PLAT ID NUMBER 046-06

American Lotus Subdivision
Master Development Plan
120.66 AC.

Re: American Lotus Subdivision **MDP # 046-06**

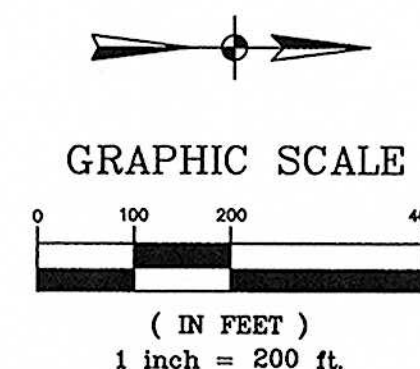
In consideration of public safety and convenience, excessive grades by reason of topography should be avoided in street layouts and arrangements.

DSD – Traffic Impact Analysis & Streets indicates the following requirements and on-site improvements are necessary and shall be provided by the developer, on and before the completion of American Lotus Subdivision **MDP # 046-06**, at no cost to the City of San Antonio.

- Secondary access must be in place prior to the approval of any plat or combination of plats that exceed more than 125 lots.
- All sidewalks shall comply with Sec. 35-506 (q) of the Unified Development Code (UDC).
- All Roadways shall conform to Table 506-2: Functional Classification System Description for Traditional Design Classification Sec. 35-506 (c) (2) of the UDC.
- Clear sight distances should be provided at each roadway intersection to allow adequate, obstruction-free viewing distances for approaching traffic. All signage, landscaping, and improvements shall be selected and located so as to not obscure the minimum intersection visibility.
- Once the number of platted lots accessing the "collector", identified as American Lotus, exceeds 800, a secondary access to American Lotus Subdivision will be required.

It should be understood that this is a general review of a conceptual plan not an in-depth review of internal and external traffic flow, or streets and drainage plans. The internal street network shall be planned in order to provide safe and efficient movement of traffic to and from, within and past, the proposed development, while minimizing the impact to non-site trips. All technical requirements of the Unified Development Code will be complied with at the time of platting.

Tree Preservation states the project is both vested and unvested.

- The unvested portion of the project will be subject to the Tree Preservation Ordinance standards per Sec. 35-523 of the UDC. A Tree Preservation Plan is required prior to any work on lots on the site. This can be submitted either as a site work permit or at the platting stage. Additional permitting fees and affidavits will be needed to obtain tree permits. A tree permit for clearing ROW has been approved for this project under A/P 1298280.
- The vested portion of the project is exempt from the 1997 Tree Ordinance based on Vested Rights Permit # 06-03-037R as of July 24, 1985.

Parks and Recreation states the following:

- American Lotus is a proposed subdivision with 142 single-family residential units which are not vested. UDC Section 35-503, Table 503-1 states that single-family development is required to provide 1 acre of park/open space per every 70 dwelling units. The requirement for this development is 2.0 acres.
- The applicant has requested to pay a fee-in-lieu of providing parkland dedication. The fee must be paid prior to the recordation of the first plat associated with the unvested portion of the plan.

Bexar County states the following will apply prior to completion of American Lotus Subdivision:

- The intersection of Potranco (FM 1957) and American Lotus Subdivision is expected to operate at a level of service F with the current roadway conditions as well as with improvements to FM1957 to a four lane divided roadway. Bexar County recommends the developer to work with TXDOT to analyze additional mitigation efforts.
- It is understood that this MDP is a conceptual plan and all regulations will be addressed at the time of platting.
- Bexar County reserves the right to address driveways, street design, sight distance, ADA requirements, drainage and floodplain issues at time of platting.
- Secondary access shall be secured to Groesenbacher Road prior to the approval of any plat for American Lotus Subdivision.

REVISED AS PER MDP COMMENTS
10/09/06
12/14/06
02/15/07
AGUED NOTE 19

19. ONCE THE NUMBER OF PLATTED LOTS ACCESSING THE "COLLECTOR", IDENTIFIED AS AMERICAN LOTUS, EXCEEDS 800, A SECONDARY ACCESS TO AMERICAN LOTUS SUBDIVISION WILL BE REQUIRED.
